TECHNICAL EVALUATION REPORT

CONTROL OF HEAVY LOADS (C-10)

TOLEDO EDISON COMPANY
DAVIS-BESSE NUCLEAR POWER STATION UNIT 1

NRC DOCKET NO. 50-346

Figure 1. Restricted Region for Class 2 Loads in Containment

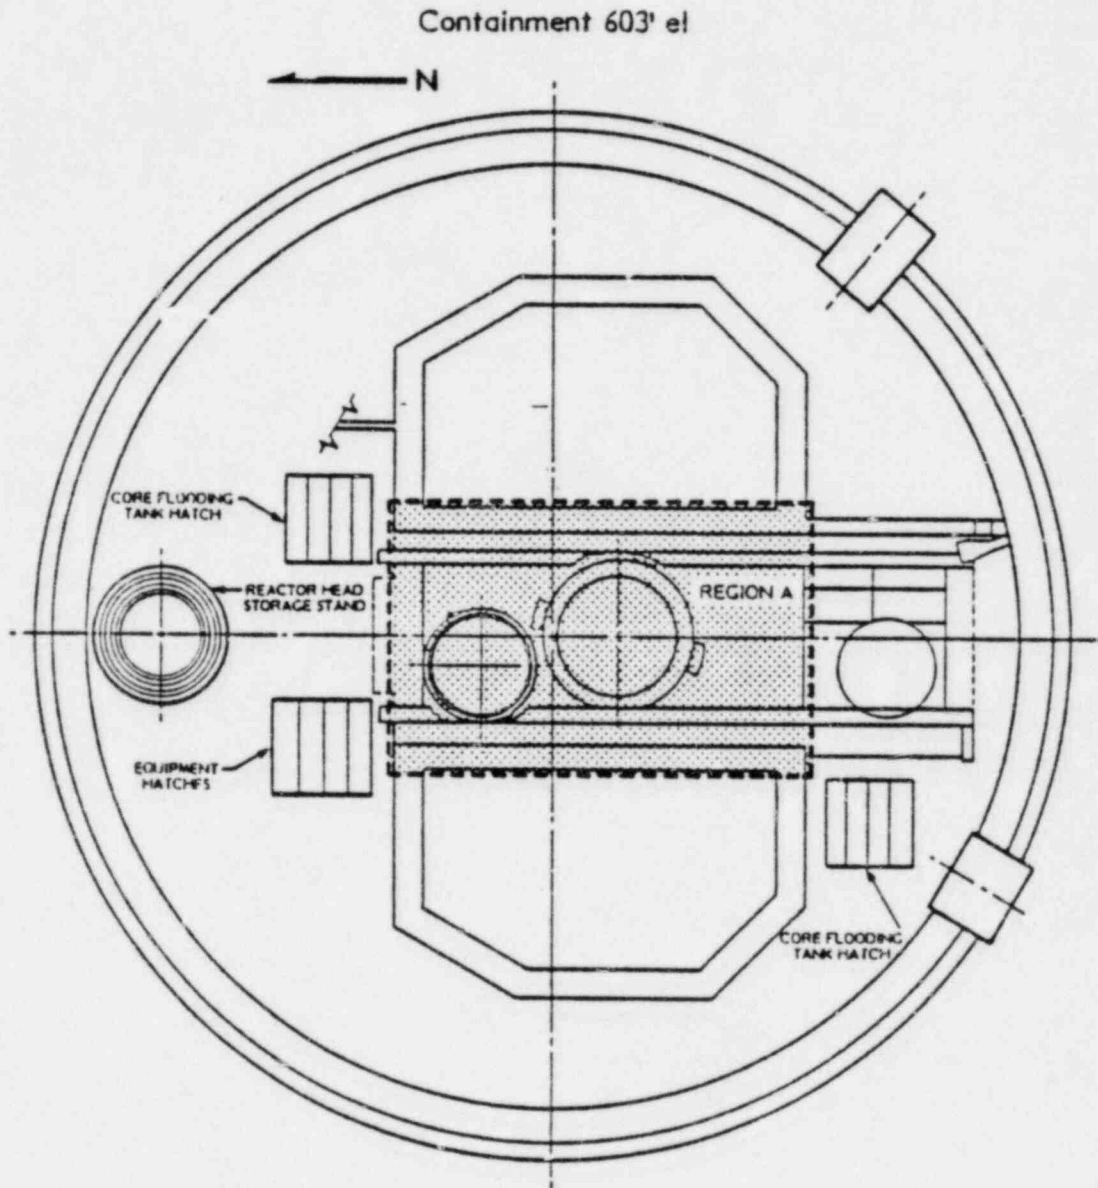
For Handling Class 2 loads, no physical or design restrictions prevent these loads from being carried over the reactor vessel; therefore, a procedural restriction has been added to the appropriate procedure to prohibit movement of these loads directly over the reactor vessel when spent fuel is in the vessel (Region A of Figure 1).

Figure 2. Area Where Load Drop Could Damage Safe Shutdown Equipment

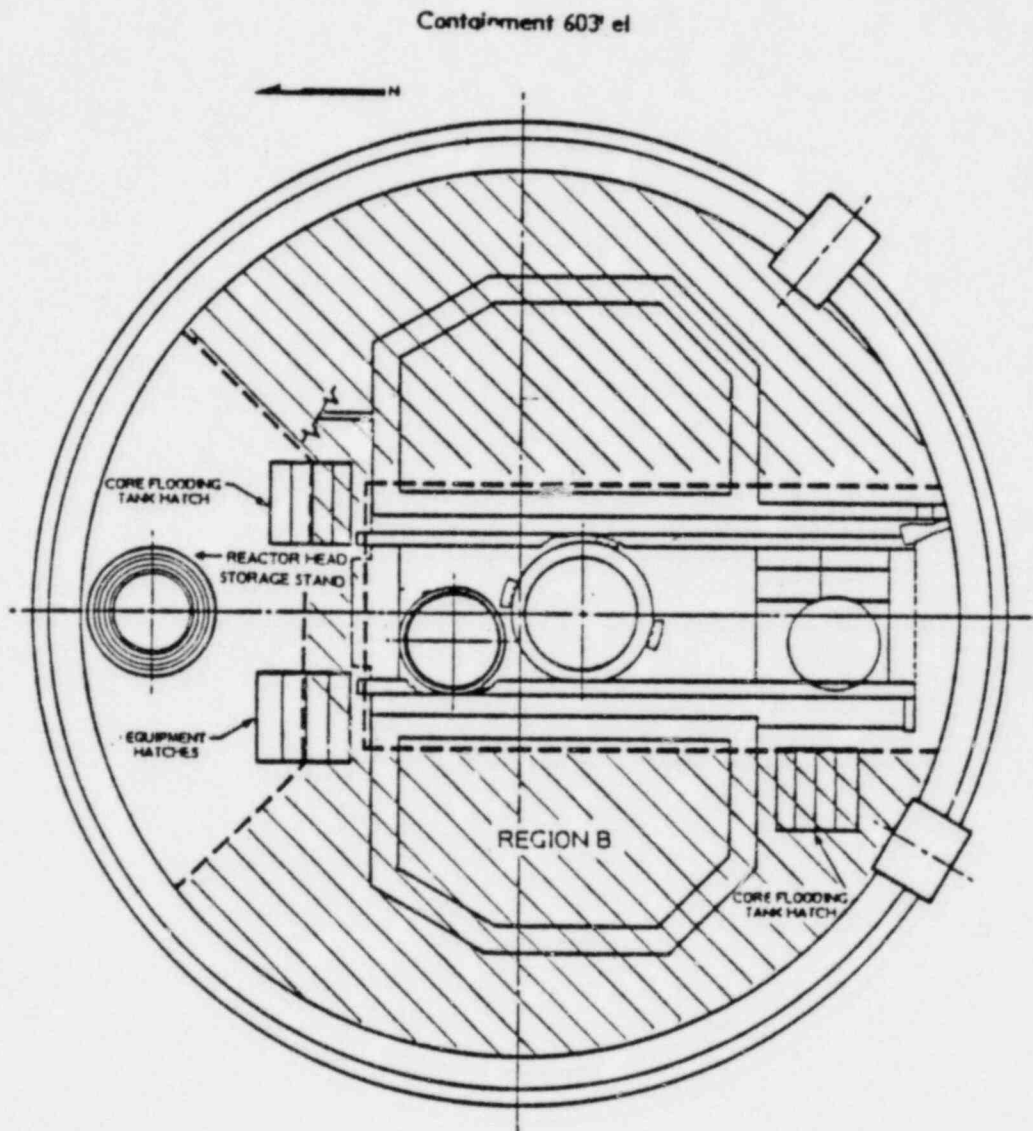
The principal concern regarding loads in Handling Class 3 is the potential for these loads to impact equipment required to maintain safe shutdown. Based on a cursory review, the area that could contain safe shutdown equipment is indicated in Figure 2 as Region B. For Class 3A loads, no specific load paths are judged to be necessary on the basis of preliminary evaluations of the

potential for damage to equipment below the refueling floor. Procedures will require only that these loads be carried at the minimum height necessary above the refueling floor to accomplish the lift. All Class 3B loads will be carried to the minimum height necessary.
